November 29, 2022

**RE: Response to Peer Review Comments – Proposed Starbucks  
399 Union Street (Route 135), Ashland, MA**

The purpose of this letter is to present a summary of our comments and the most recent response to comments provided by RMA. The following is a summary timeline of the correspondence between McMahon, RMA, and the Town of Ashland related to this review.

**LAYOUT & MATERIALS PLAN**

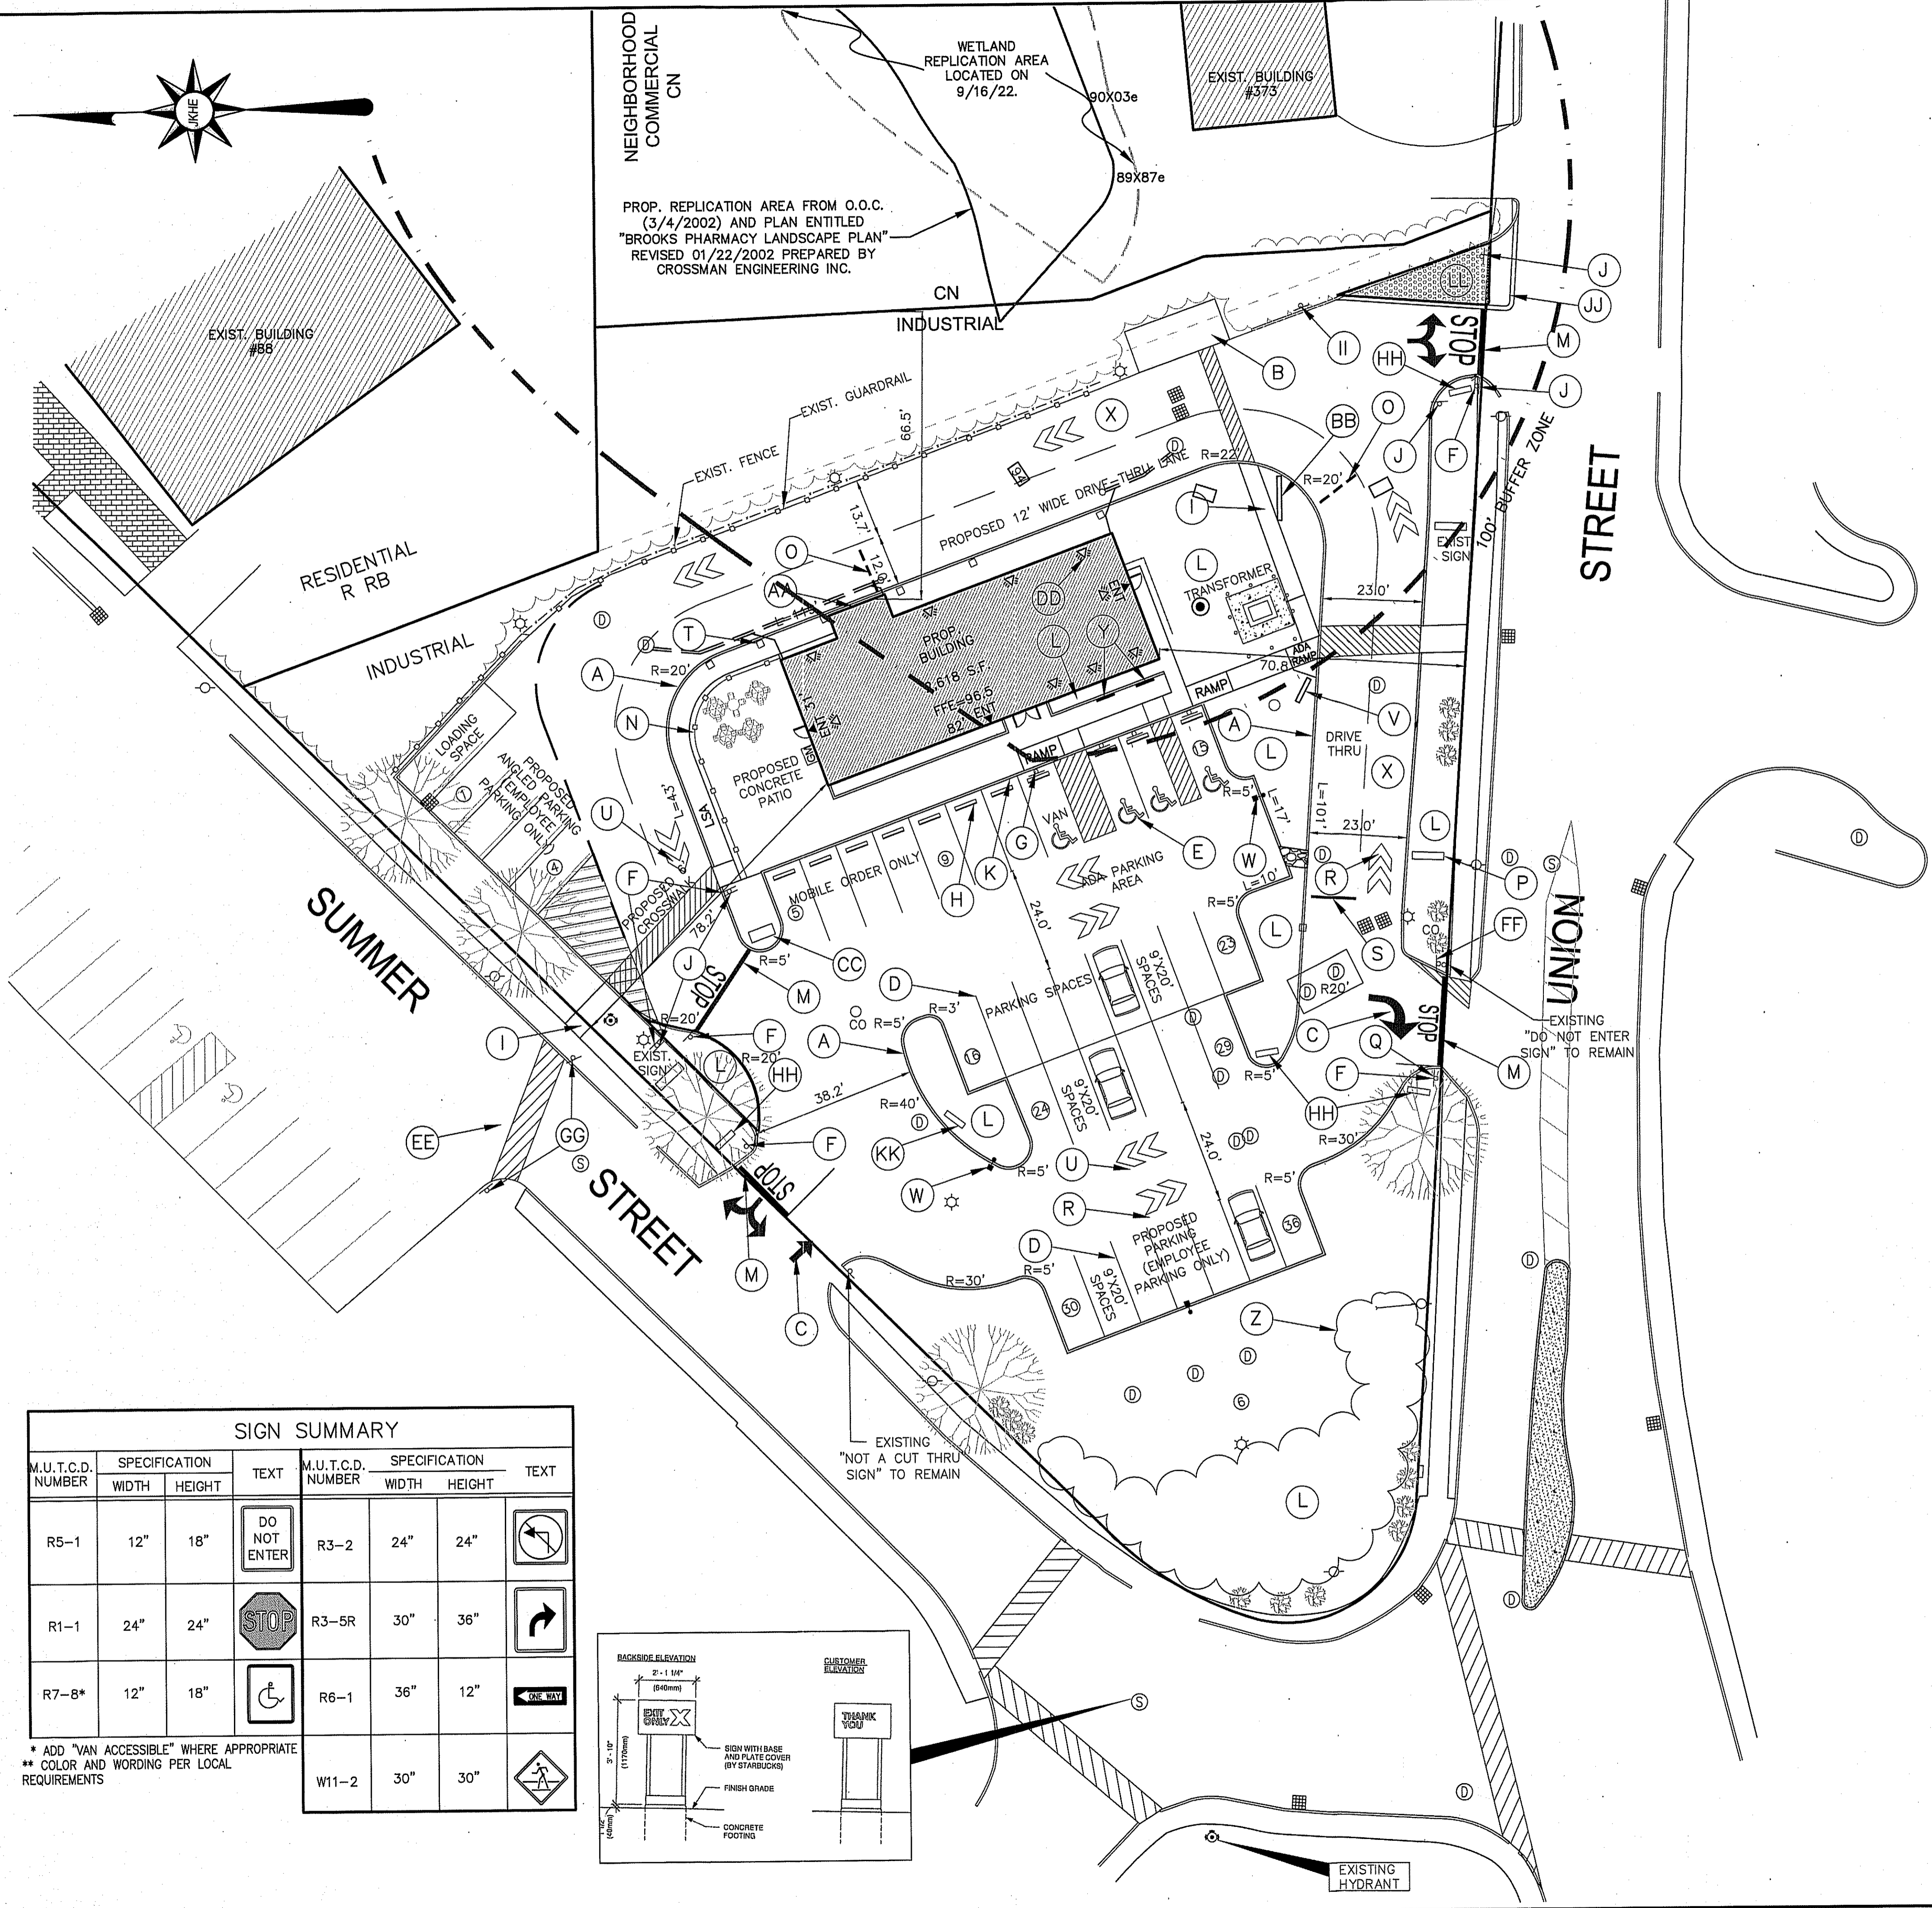
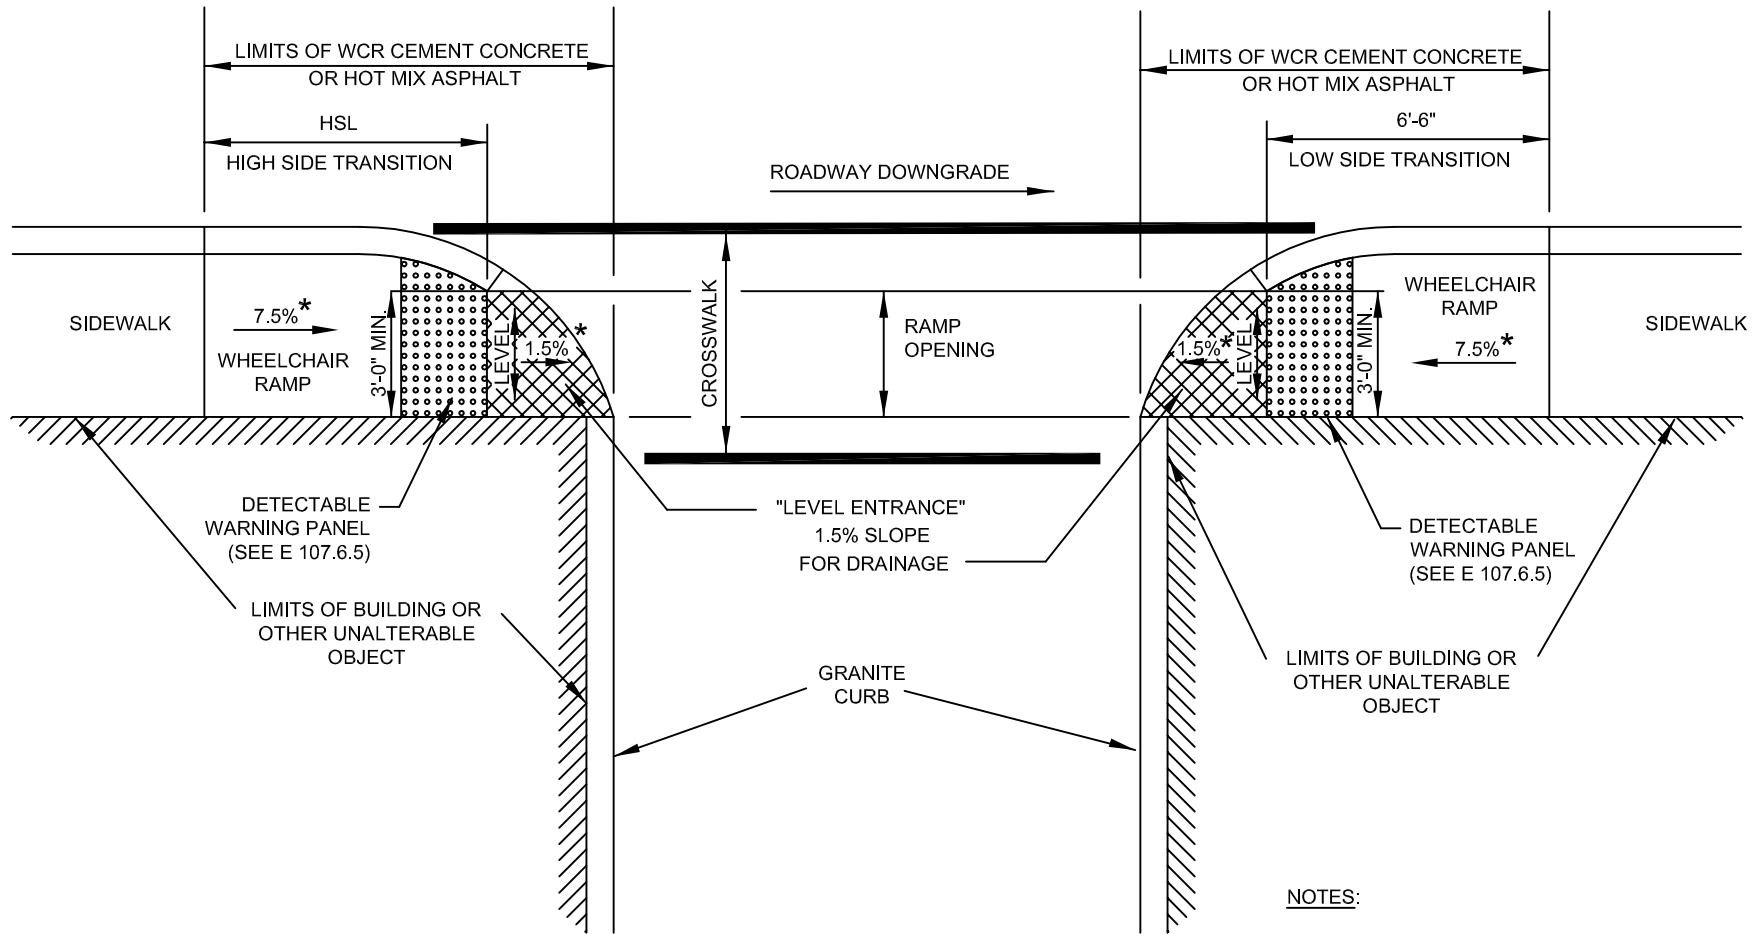
**RMA Comment 19: Since site traffic destined to the east on Union Street will need to use the bypass lane to access the east site driveway, we recommended that the width of the bypass lane be a minimum of 12 feet. The revised site plan shows a combined width of 23 feet for the drive-through lane and bypass lane with Note X indicating the bypass lane be a minimum of 11 feet in width. Note X should be revised to say 12 foot minimum width for the bypass lane.**

**However, the easterly Union Street driveway is proposed to be narrowed by creating a landscaped area adjacent to the property line and surrounded by a cape cod berm to allow emergency vehicles to cross over this island. The DO NOT ENTER sign proposed within this landscaped area will need to be relocated to allow emergency vehicles' use of this area. The area identified as landscaped should not contain any trees or shrubs and should be constructed of grass-covered porous pavement (such as GrassPave or similar) to assure that emergency vehicles can travel over this area. Finally, the Town should consider requiring sloped granite edging around this area as opposed to cape cod berm for durability.**

**RMA Comment 27: We recommend that the drive-through lane be clearly marked through signing and striping including DRIVE THRU pavement markings with pavement arrows. The updated site plan shows pavement markings to indicate the drive-through lane, but no signs are proposed to direct customers to the drive-through. The applicant should consider installing a sign on the landscaped island opposite the Summer Street entrance directing customers to the right toward the drive-through.**

*McMahon Response: Note X on the Site Plan has been revised to indicate a minimum width of 12-feet for the bypass lane. The updated Layout & Materials Plan, prepared by J.K. Holmgren Engineering is provided as an attachment.*

*McMahon Response: The proposed DO NOT ENTER sign at the East Site Driveway on Union Street has been relocated such that it is outside of the turning path of an emergency vehicle accessing the site. Trees or plantings are not proposed within the landscaped area located at the East Site Driveway. Grass pavers will be used on the landscape area to allow for emergency vehicle access via this driveway.*

*McMahon Response: Additional wayfinding signage for the drive-thru entrance has been added to the landscaped island opposite the Summer Street entrance as shown in the updated Layout & Materials Plan.*

**WHEELCHAIR RAMP FOR ONE CONTINUOUS DIRECTION OF PEDESTRIAN TRAVEL**

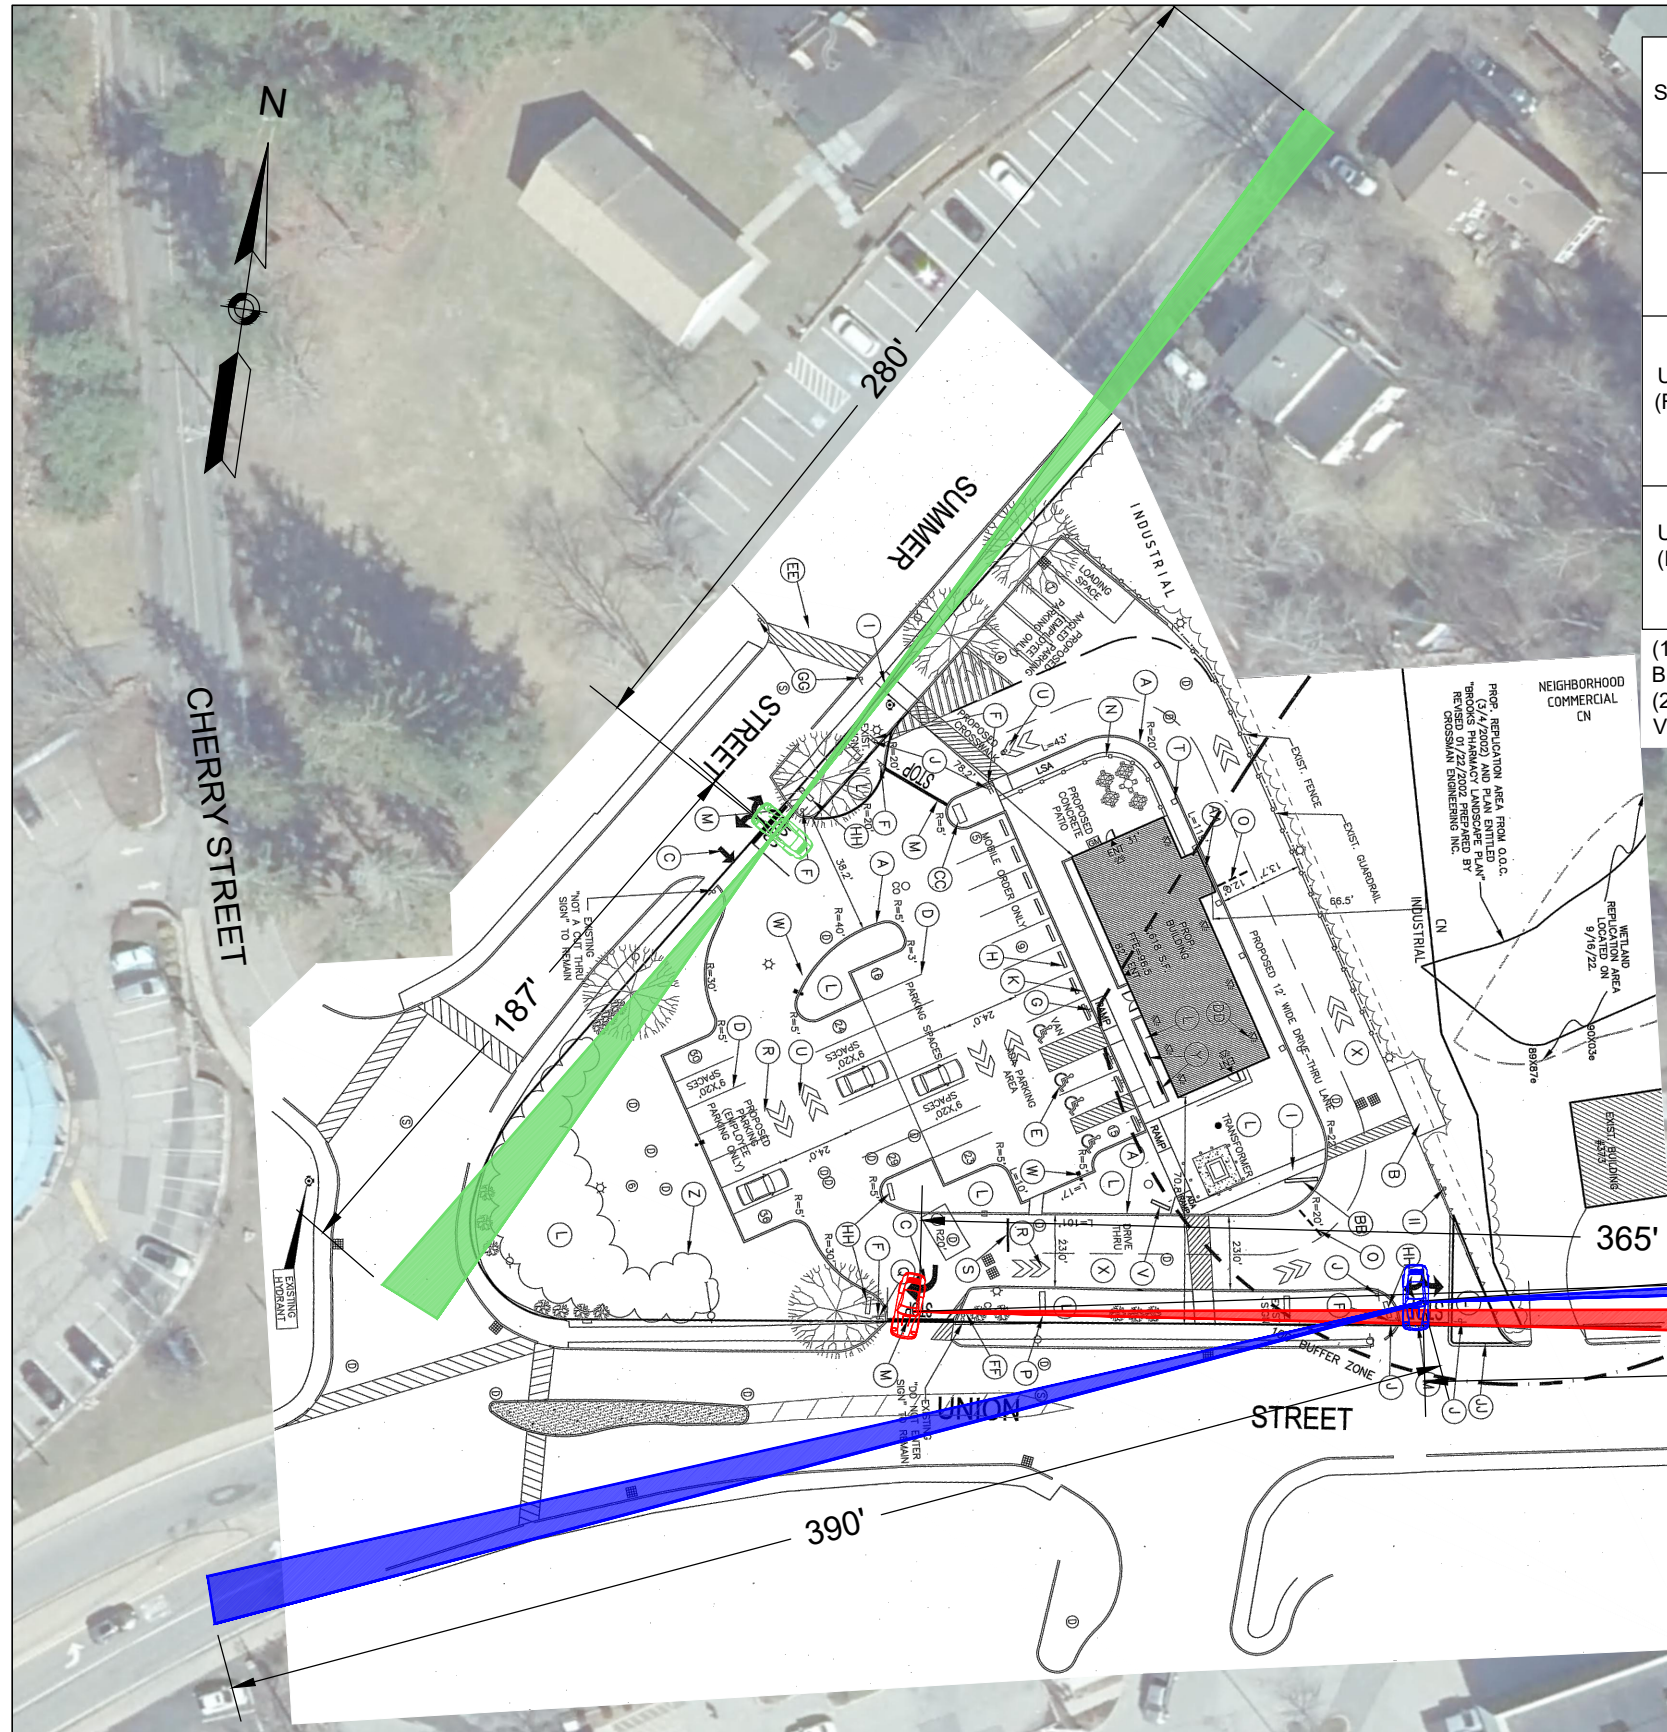
**RMA Comment 26: We recommend that all proposed sidewalks provide ADA-compliant wheelchair ramps. The applicant responded that a crosswalk is not proposed across Summer Street connecting the Starbucks with the KidSpot Playground and Stone Park area. The updated site plan provides details for two types of wheelchair ramp configurations, but the tactile warning panel locations on one of these details is incorrect. The crosswalk detail should be corrected to show the tactile warning panels within the level landing area of the ramp. A detail should also be provided showing the sidewalk and wheelchair ramp configuration for the easternly Union Street driveway where a mountable curb is proposed to narrow this driveway to exiting movements only while still allowing a fire truck to navigate this driveway. In addition, it is recommended that rectangular rapid flashing beacons (RRFB) be installed at the Summer Street crosswalk.**

*McMahon Response: Based on guidance provided by the Federal Highway Administration (FHWA), the use of RRFBs should be reserved "for locations with significant pedestrian safety issues, as over-use of RRFB treatment may diminish their effectiveness". Crash records obtained from MassDOT along Summer Street in the vicinity of the project site do not indicate any crashes involving a pedestrian. Warning signs are proposed at the Summer Street crosswalk to provide additional caution to drivers. A standard crosswalk detail has been provided as an attachment and will be incorporated into the final site plans.*

FIGURE 1  
AVAILABLE SIGHT LINES

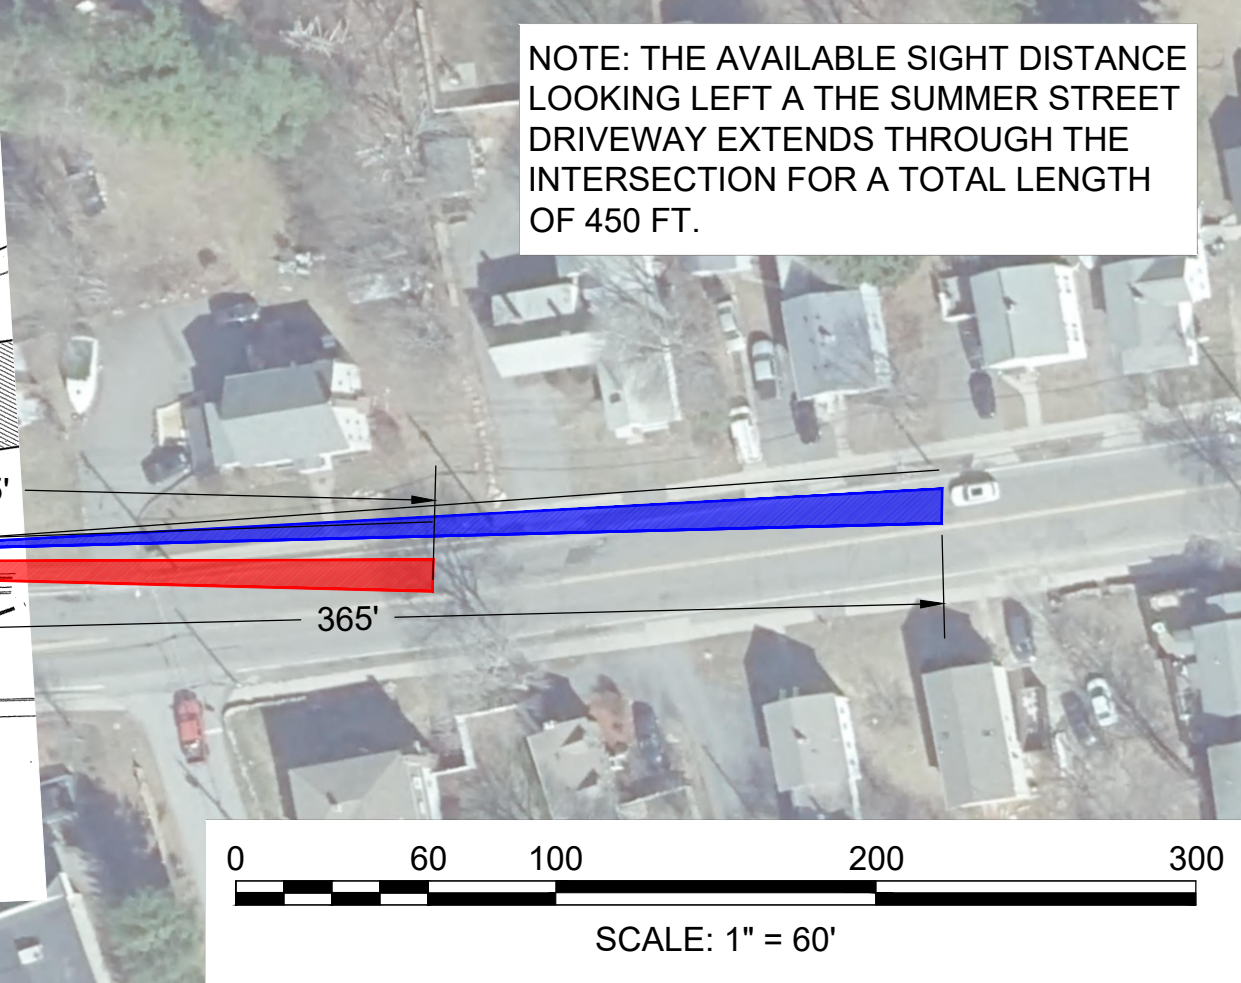
**RMA Comment 16: We recommended that vehicle speed data be collected on Union Street to ensure that sight lines for vehicles exiting the easternly driveway will exceed minimum requirements based on the observed 85<sup>th</sup> percentile speeds. The applicant collected speed data on Union Street and presented an updated sight distance table based on the 85<sup>th</sup> percentile speeds of 34 mph eastbound and 33 mph westbound. However, our review of the automatic traffic recorder used to collect the speeds shows 85<sup>th</sup> percentile speeds of 39 mph eastbound and 41 mph westbound during times that the proposed Starbucks is likely to be open for business. The measured sight lines, however, would still exceed the minimum requirements based on these speeds. The applicant notes that the removal of existing vegetation is necessary to achieve the minimum sight distance requirements. This should be made a condition of any approval of the project. See also Comment 29.**

**RMA Comment 29: We recommended that the sight lines be shown on the site plan to clearly identify the areas of vegetation clearing necessary to achieve minimum sight distance requirements. The applicant submitted a sight line exhibit using aerial imagery, however the**

**exhibit shows a 500-foot line of sight to the east of the easternly Union Street driveway that, if implemented, would require clearing of vegetation on private property. It is recommended that the sight line plan for the driveways be updated showing the minimum required sight lines based on the observed 85<sup>th</sup> percentile speeds of 39 mph eastbound and 41 mph westbound and that these lines be shown on the site plan, not on an aerial image to be able to ascertain whether any existing or proposed signs and landscaping would impact the available sight lines.**

*McMahon Response: Speed data was collected on Union Street (Route 135) east of the project site for a 72-hour period. Although higher vehicle operating speeds were observed during off-peak times where the vehicle volumes were low, it is standard practice to apply the overall 85<sup>th</sup> percentile speed over the course of*

*the entire day when evaluating the sight distance requirements. The measured 85<sup>th</sup> percentile speeds on Union Street (Route 135) were measured to be 34 mph in the eastbound direction and 33 mph in the westbound direction.*

*McMahon Response: The sight line graphic has been revised to reflect the appropriate travel speeds and illustrate the sight lines on the site plan and is provided as an attachment.*
